SUBJECT: U.S. NUCLEAR REGULATORY COMMISSION TECHNICAL EVALUATION
REPORT ON THE U.S. DEPARTMENT OF ENERGY PHASE 1
DECOMMISSIONING PLAN FOR THE WEST VALLEY DEMONSTRATION
PROJECT

TECHNICAL EVALUATION REPORT

Figure 1 Site Map Showing Areas to Be Remediated in Phase 1

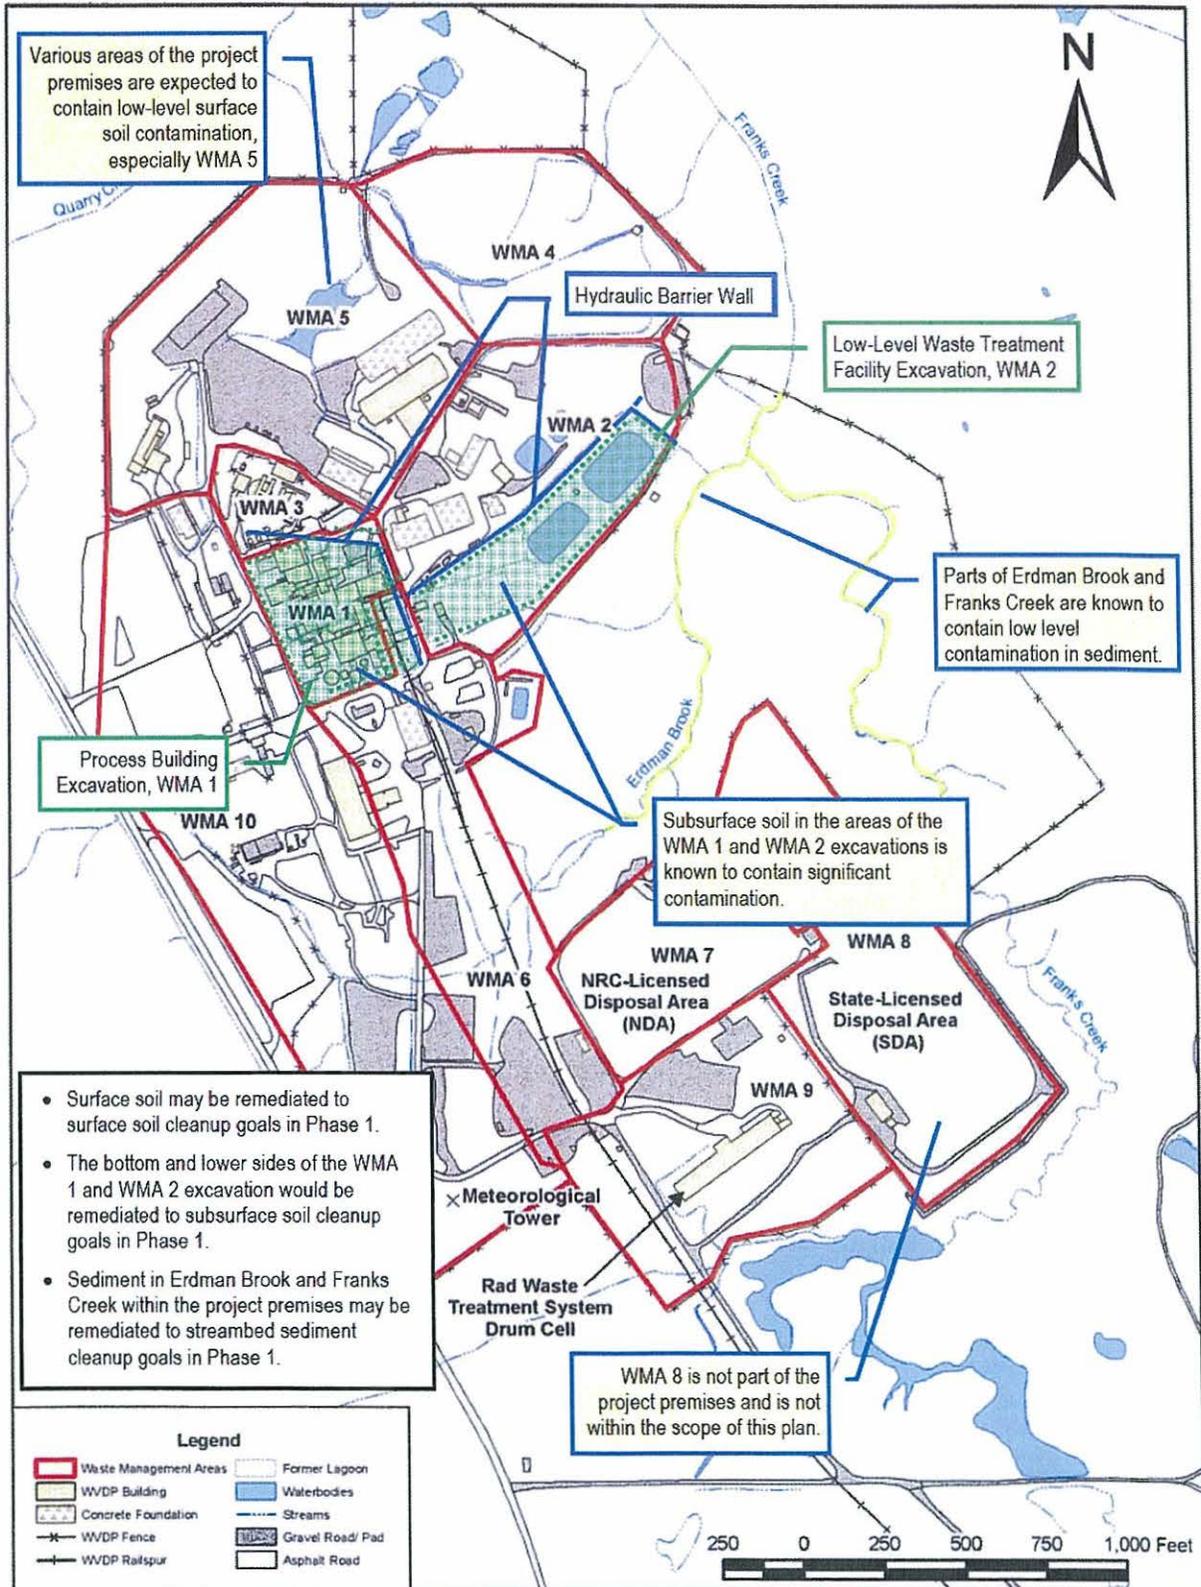
Comment: If previously cleaned areas become re-contaminated, the collection of additional information during the ongoing assessment period reveals that risks are significantly underestimated, or modeling assumptions otherwise become invalid, NRC expects that the impact of these events on the ability of the site to meet LTR criteria will need to be re-evaluated at the time of final decommissioning.

Figure 2 Conceptual Model for Development of Surface Soil DCGLs

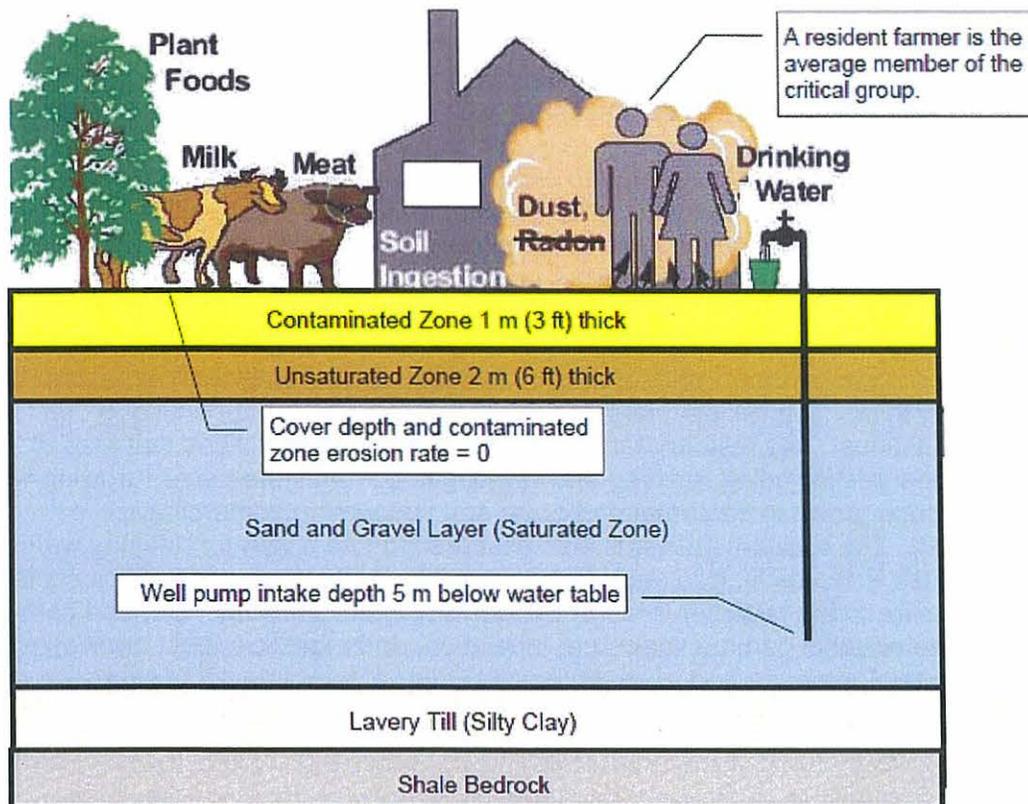
Comment: Dose modeling assumptions regarding the lateral and vertical extent of contamination needs to be verified in the field. If significant deviations exist, DOE needs to: (i) evaluate the risk significance of these deviations; and if necessary; (ii) revise the DCGLs; or (iii) apply the DCGLs to just those areas of the site where the dose modeling assumptions are valid. This comment applies to surface, subsurface, and streambed sediment soils.

Figure 4 Conceptual Model for Streambed Sediment DCGL Development

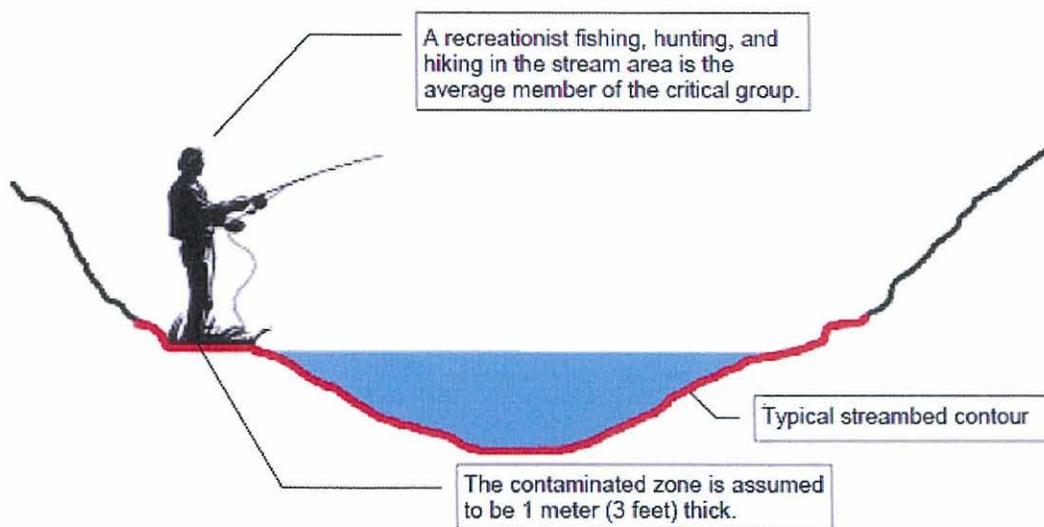
Comment: DOE did not provide a rationale for using the Buttermilk Creek watershed area when deriving streambed sediment DCGLs. NRC recommends that DOE justify use of the Buttermilk Creek watershed area to calculate surface water concentrations in the streambed sediment DCGLs prior to their use in a future DP revision.

Figure 5 Alternative Conceptual Model for Development of Subsurface Soil DCGL: Groundwater Transport (Diffusion) From Lavery Till to Backfill Sediments with Subsequent Well Withdrawal

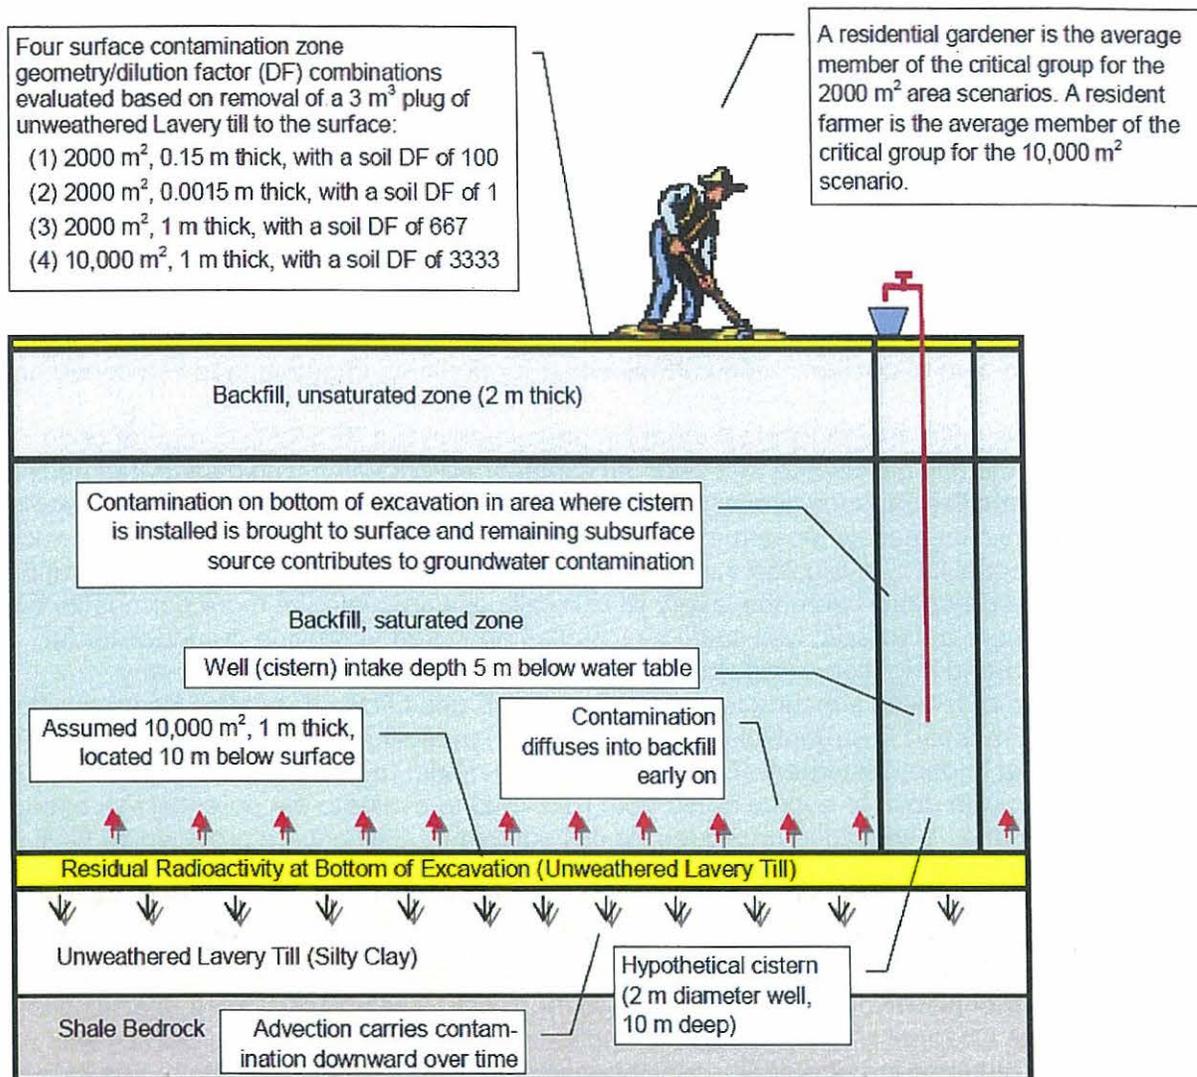
Comment: DOE did not demonstrate that diffusive transport is the dominant transport mechanism of contamination from the lavery till into the overlying aquifer. DOE needs to more formally document its conclusion that advective flow from the lavery till to the backfill sediments is not the dominant transport mechanism for the groundwater transport (or multi-source) scenario.

Figure 8 - DOE's Proposed Use of Permanent Engineered Barriers for Phase 1 Decommissioning Activities and Associated Monitoring Locations

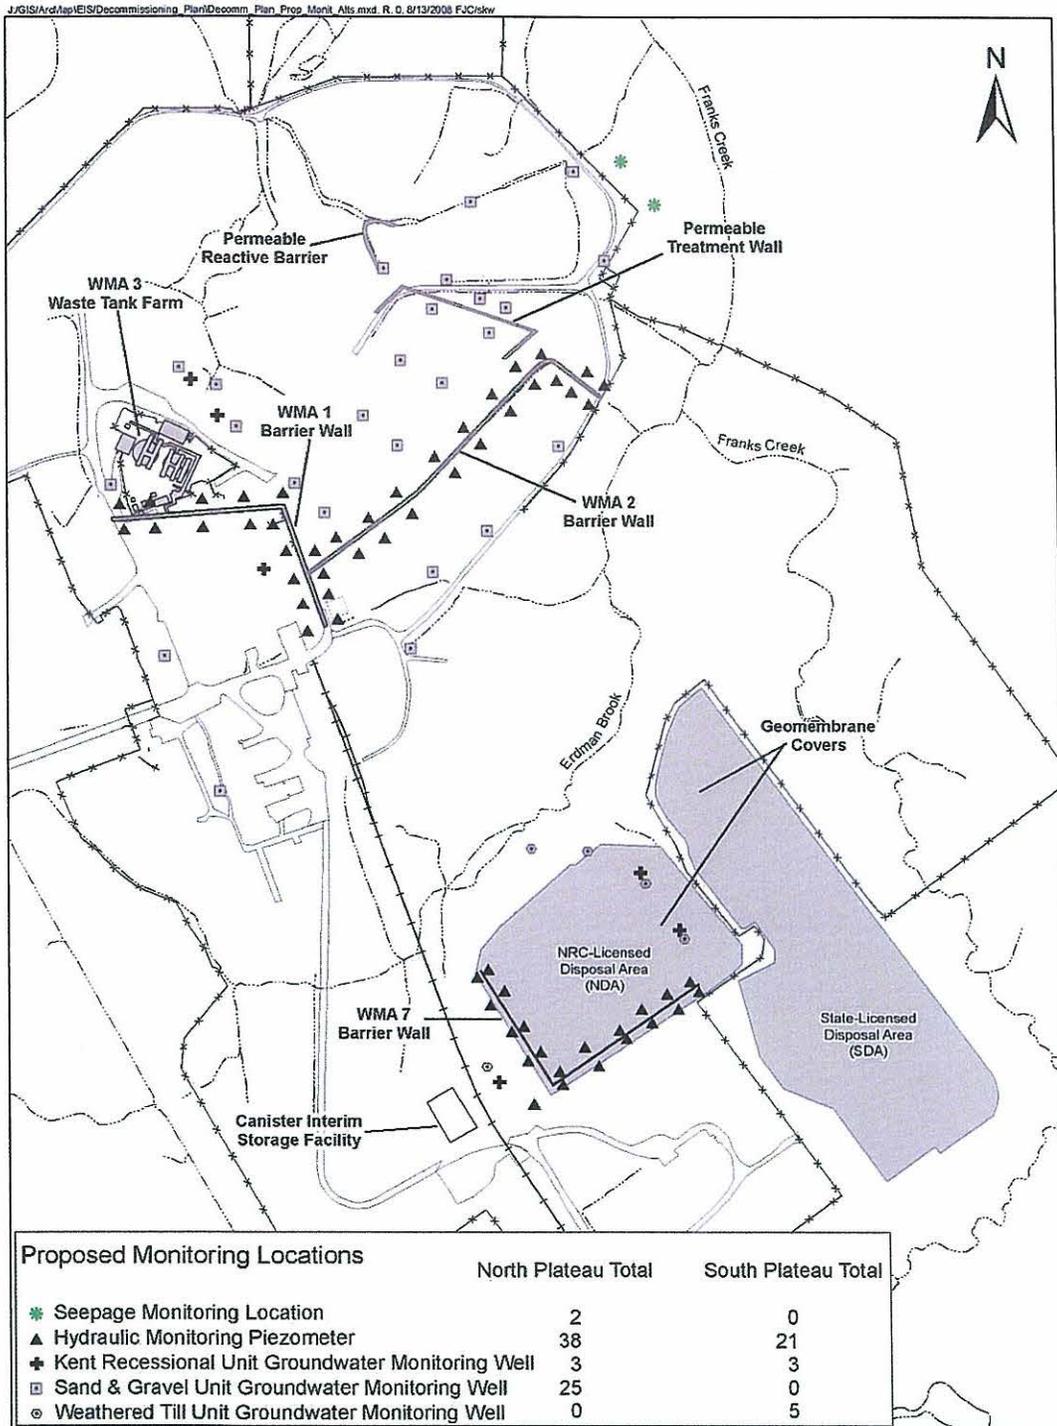
Comment: Potential adverse impacts of final engineered barrier designs have not been evaluated at this time. DOE needs to evaluate any potential adverse impacts of final engineered barrier designs that may affect risk calculations to support Phase 2 decision-making.
